ADDENDUM

<u>Addendum No.:</u>	<u>2</u>
<u>Project Name:</u>	<u>New Production Well for Parr Road Treatment Plant</u>
<u>Project No.</u>	<u>2018-011-28</u>
<u>Date:</u>	<u>May 23, 2022</u>
<u>To:</u>	<u>All Bidders</u>

MECHANICAL PLAN			
PROJECT NO.:	19-2697	SCALE:	AS SHOWN
DATE:	MARCH 2022

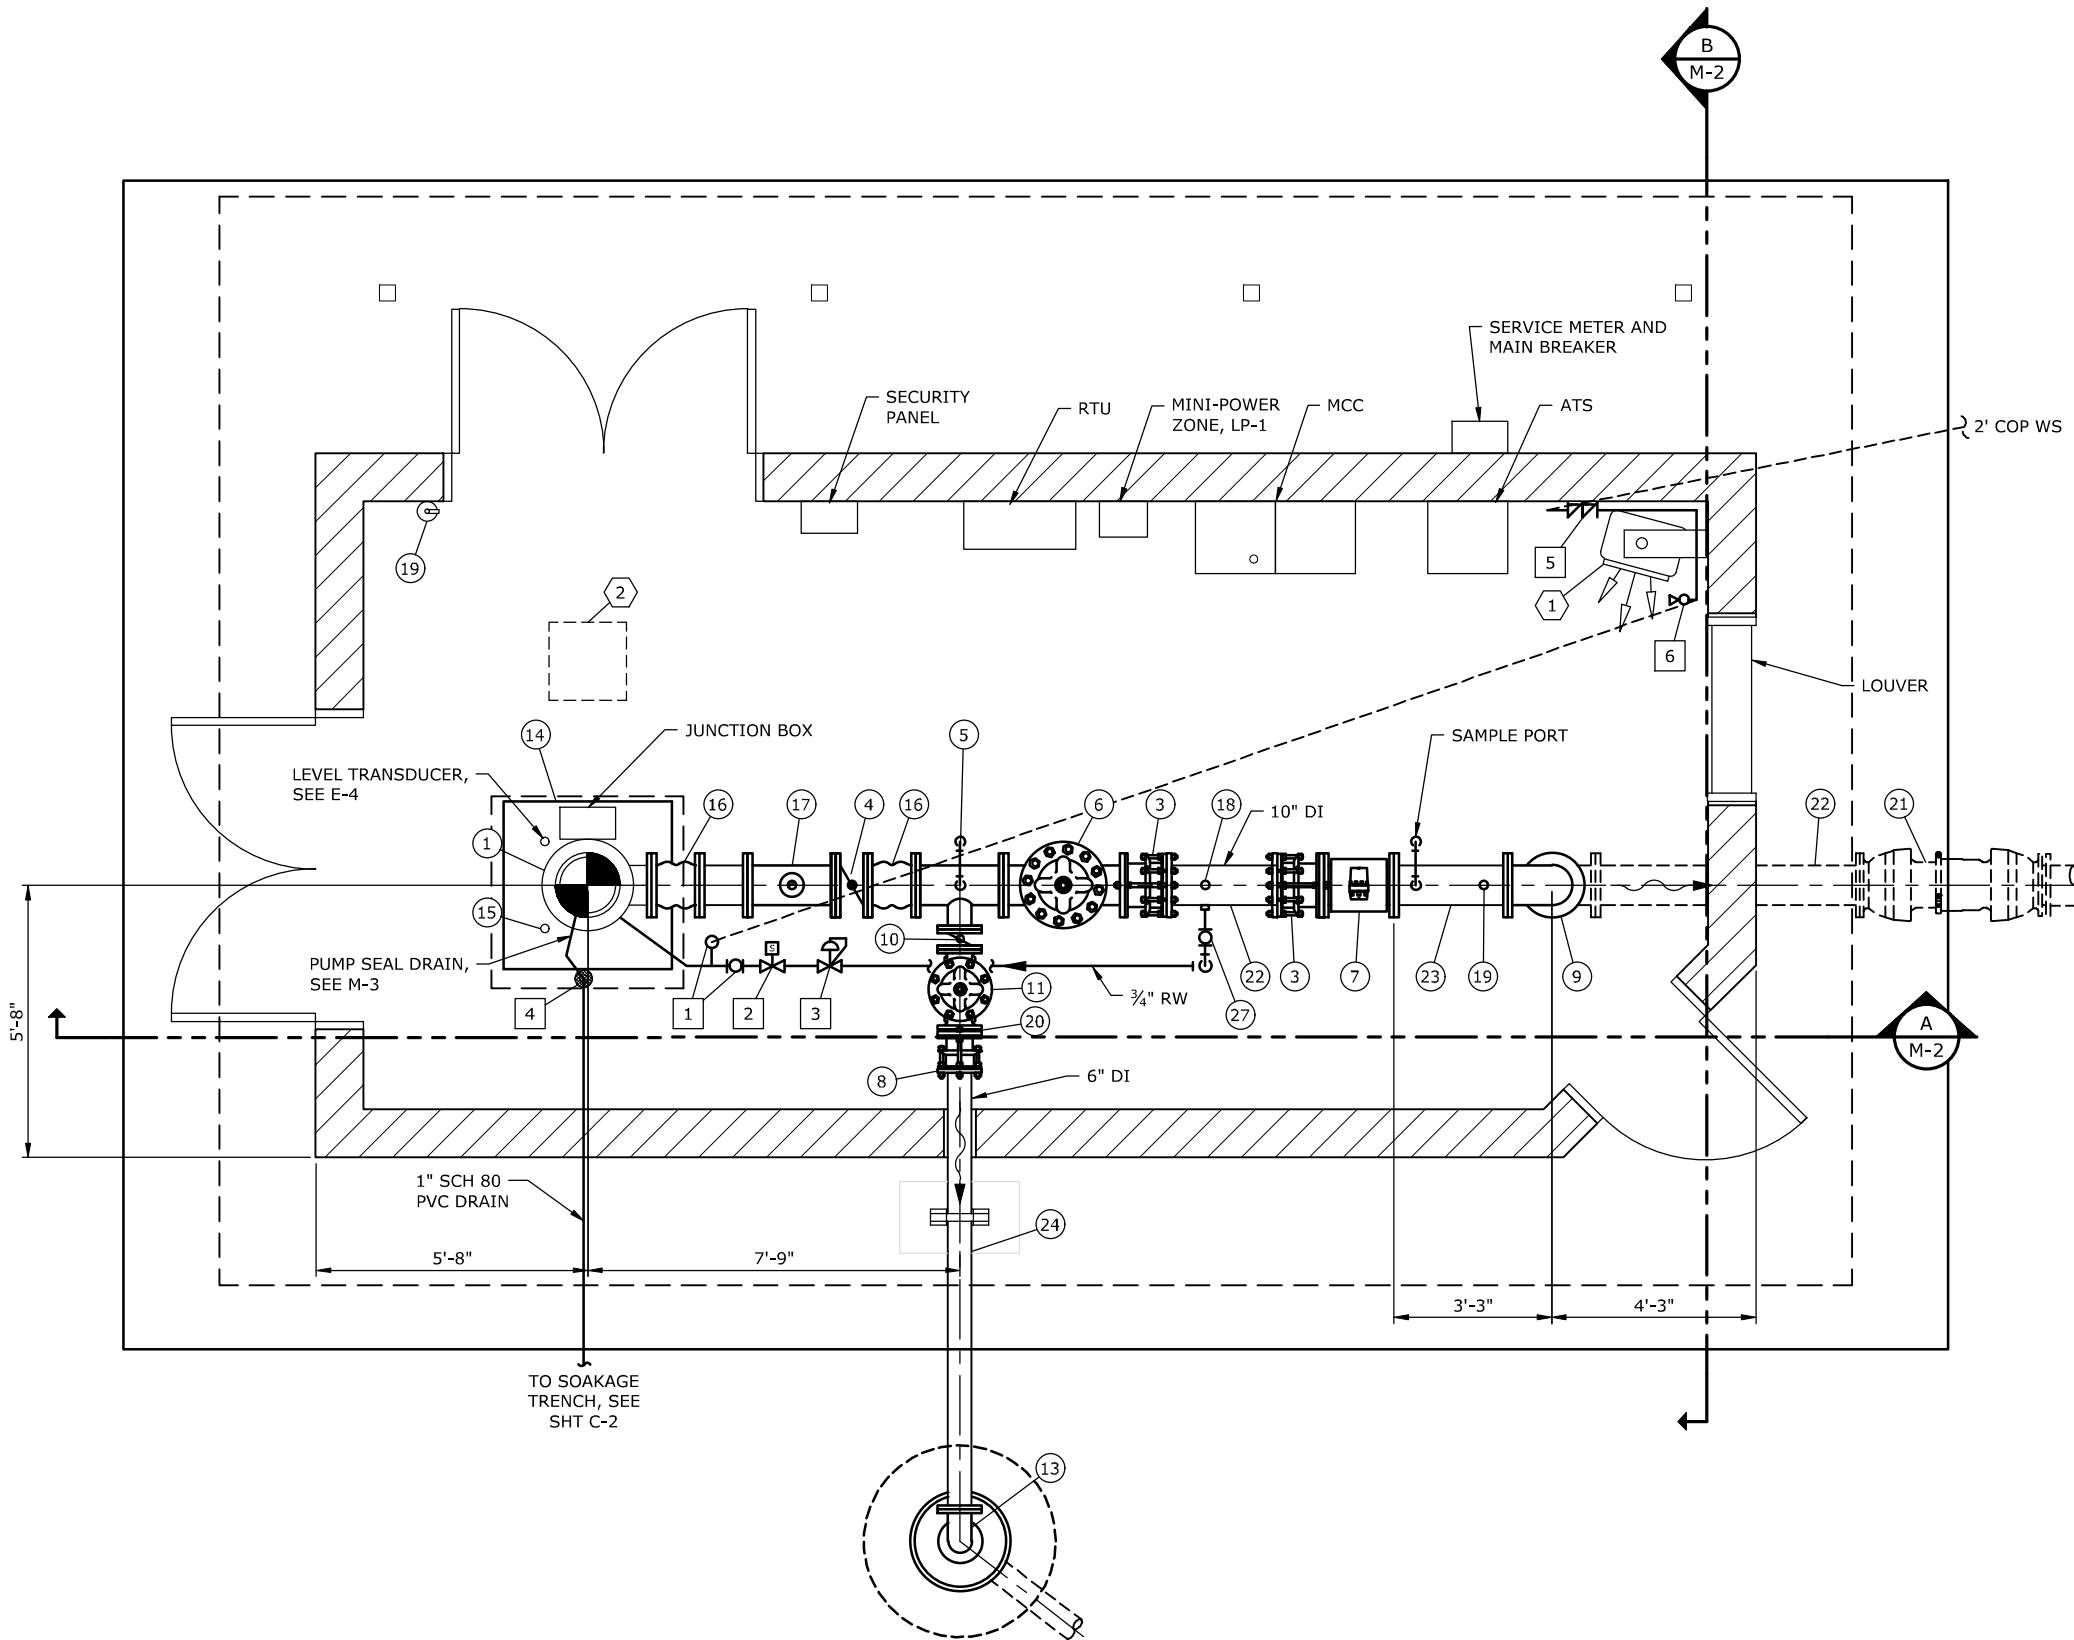
Remove and replace Sheet M-1 “Mechanical Plan” with the attached, revised sheet.

NO.	DATE	BY	REVISION
1	5/20/22	MLM	ADDENDA

| <ul style="list-style-type: none"> ① DEEP WELL VERTICAL TURBINE PUMP, PREMIUM EFFICIENCY VERTICAL TURBINE MOTOR W/ CAST IRON FLG DISCHARGE HEAD ② STANDON S89 PIPE SUPPORT, SEE NOTE 5 ③ 10" DISMANTLING JT, FLG ④ 10" BFV, FLG ⑤ 10"x6" TEE, FLG △ ⑥ 10" CHKV, CLA-VAL 81-02, SEE SPECS ⑦ 10" MAG METER, FLG ⑧ 6" DISMANTLING JT, FLG ⑨ 10" 90° BEND, FLG ⑩ 6" BFV, FLG △ ⑪ 6" DEEP WELL PUMP CV WITH PRESS RELIEF, CLA-VAL 61-07, SEE SPECS ⑫ STANDON S92 PIPE SUPPORT, SEE NOTE 5 ⑬ 6" 90° BEND, FLG ⑭ CONC PUMP BASE ⑮ WELL ACCESS PORTS, SEE DET X, SHT X - PROVIDE 1" SCHED 40 PVC CONDUIT THROUGH CONC PUMP BASE FROM ACCESS PORT TO RTU PER ELEC SHTS △ ⑯ 10" FLEX RUBBER CPLG, FLG, METRAFLEX METRASPHERE, OR EQ ⑰ 10"x2" FAB STL TEE, FLG | <ul style="list-style-type: none"> ⑱ 1/2" THREDOLET AND PRESS GAUGE ASSY ⑳ 10LB FIRE EXTINGUISHER, SEE SPECS ㉑ ORIFICE PLATE ㉒ 10" FLEX EXP JT, FLGXMJ ㉓ 10" SPL, FLGXPE, LENGTH AS REQ'D ㉔ 10" SPL, FLGXFLG, LENGTH AS REQ'D ㉕ 6" SPL, FGLXPE, LENGTH AS REQ'D ㉖ 2" DUAL PORT WELL SERVICE AIR VALVE, CLASS 250 - PROVIDE 2" SCHED 40 STL AIR VALVE VENT PIPING, ROUTE TO FLR DR - PROVIDE 1/4" COP DR LINE AT BASE OF VENT PIPING, ROUTE TO FLR DR ㉗ 2" SCHED 40 STL AIR VALVE VENT PIPING W/ INSECT SCREEN, PROVIDE BRACING AS REQ'D ㉘ PROVIDE 1" FOAM PADDING BETWEEN PIPE AND CONC PAD, CAULK TOP OF PENETRATION |
